100% REVIEW SUBMITTAL NOT FOR CONSTRUCTION

PROJECT NAME: SOUTH HILL BUILDING & TECHNOLOGY CENTER PARKING EXPANSION PUYALLUP, WA

GENERAL NOTES, LEGEND & ABBREVIATIONS

DRAWING NO.
SD-04
 22 OF 70

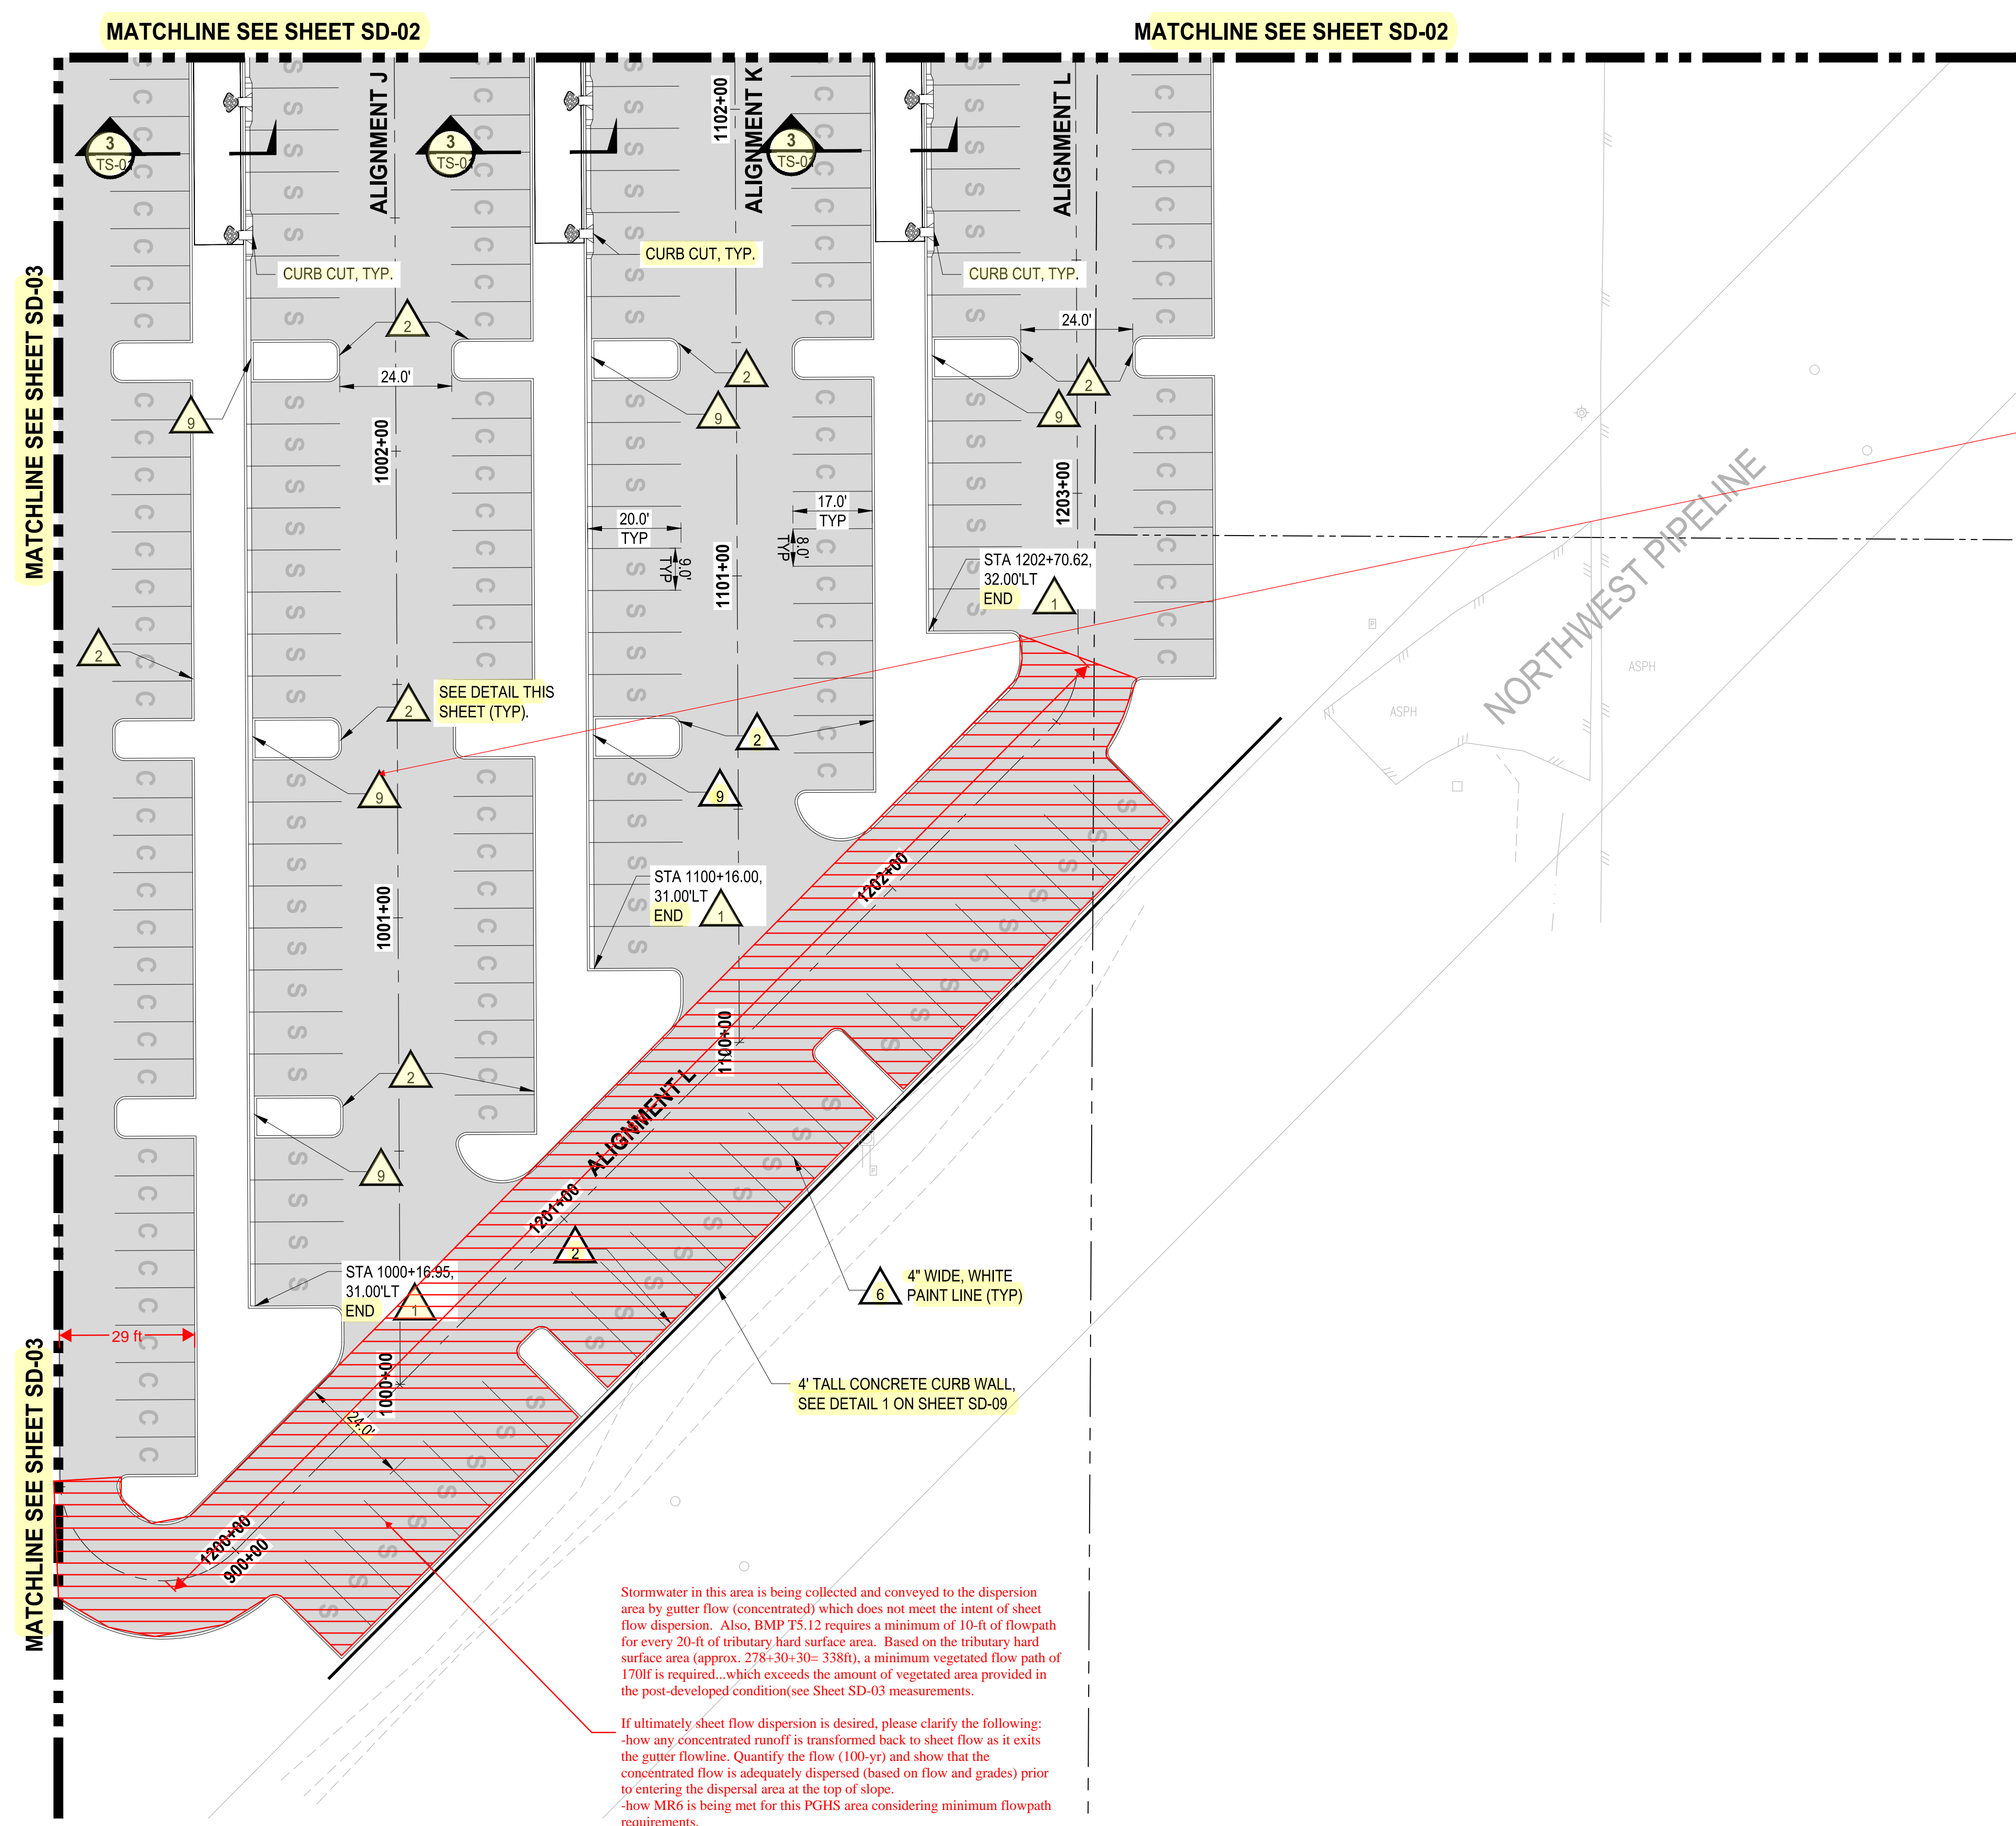
Stormwater in this area is being collected and conveyed to the dispersion area by gutter flow (concentrated) which does not meet the intent of sheet flow dispersion. Also, BMP TS.12 requires a minimum of 10-ft of flowpath for every 20-ft of tributary hard surface area. Based on the tributary hard surface area (approx. 278+30+30= 338ft), a minimum vegetated flow path of 170ft is required...which exceeds the amount of vegetated area provided in the post-developed condition(see Sheet SD-03 measurements).

If ultimately sheet flow dispersion is desired, please clarify the following:
 -how any concentrated runoff is transformed back to sheet flow as it exits the gutter flowline. Quantify the flow (100-yr) and show that the concentrated flow is adequately dispersed (based on flow and grades) prior to entering the dispersal area at the top of slope.
 -how MR6 is being met for this PGHS area considering minimum flowpath requirements.

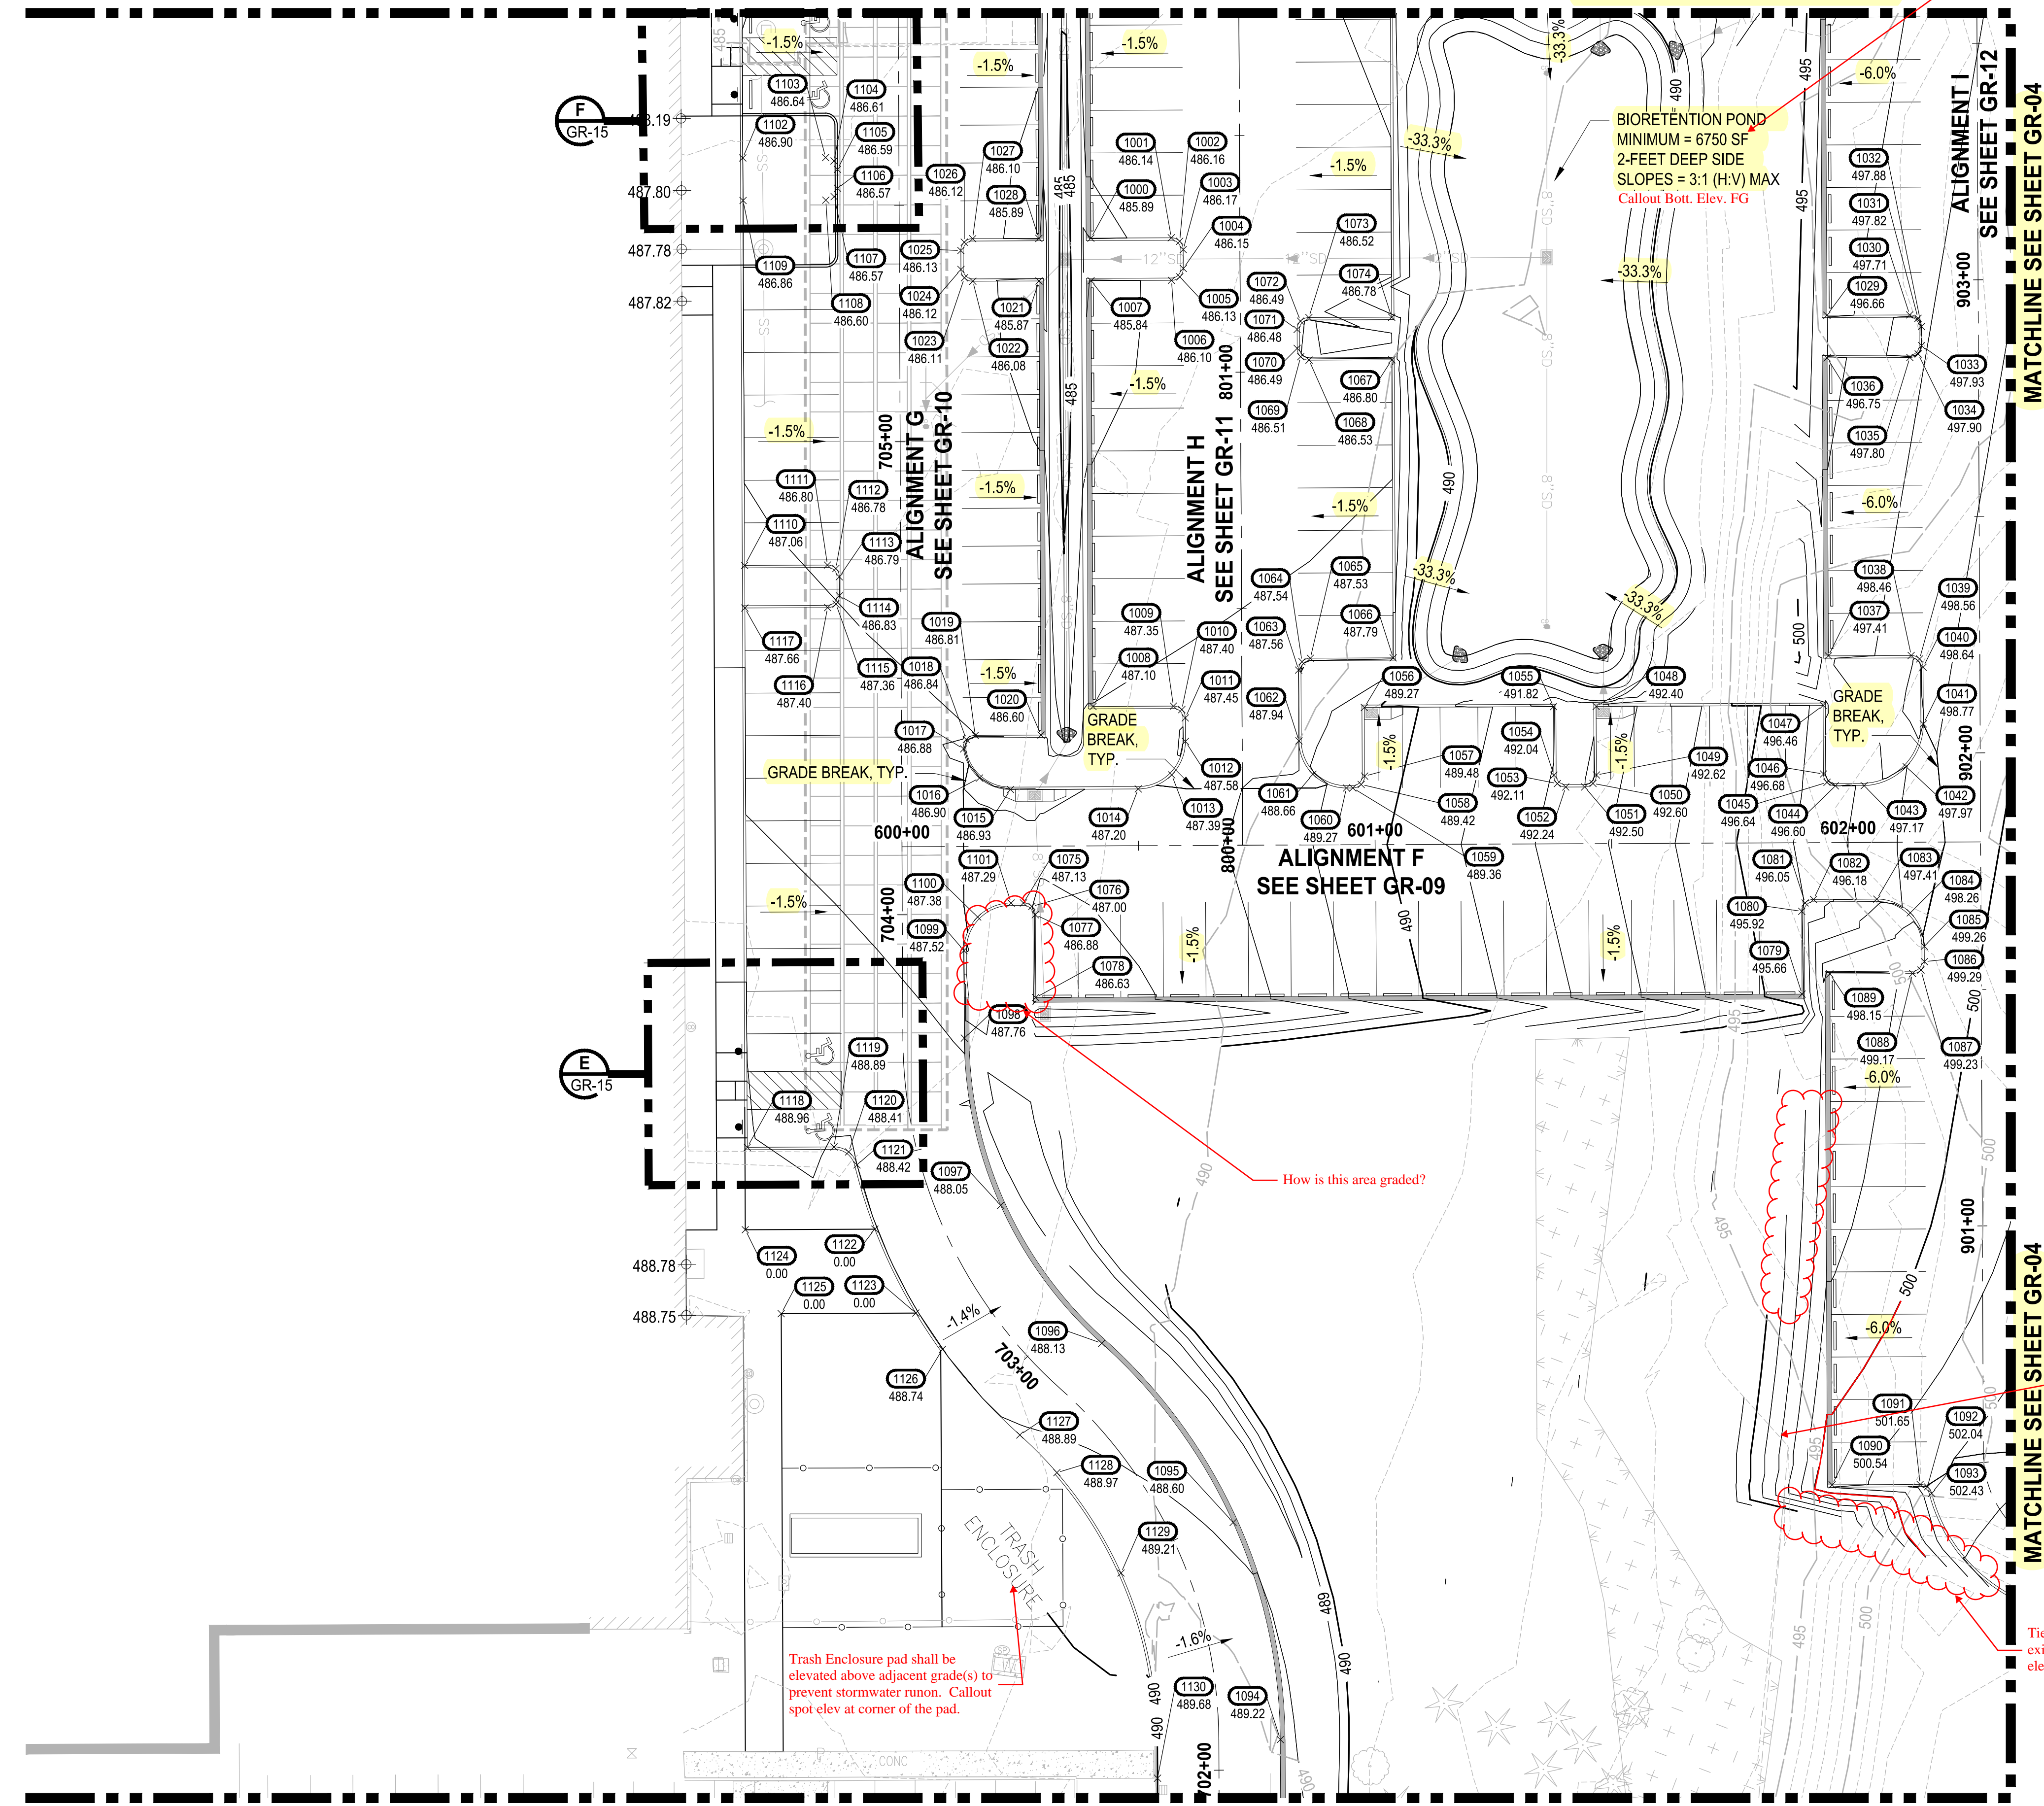
Provide letter from the geotechnical engineer that it is acceptable to discharge stormwater across this slope. Geotechnical engineer shall acknowledge anticipated 100-yr flow and provide any recommendations for slope stability and prevention of erosion. (Ref. CS Section 502.4 and Ecology BMP T5.12)
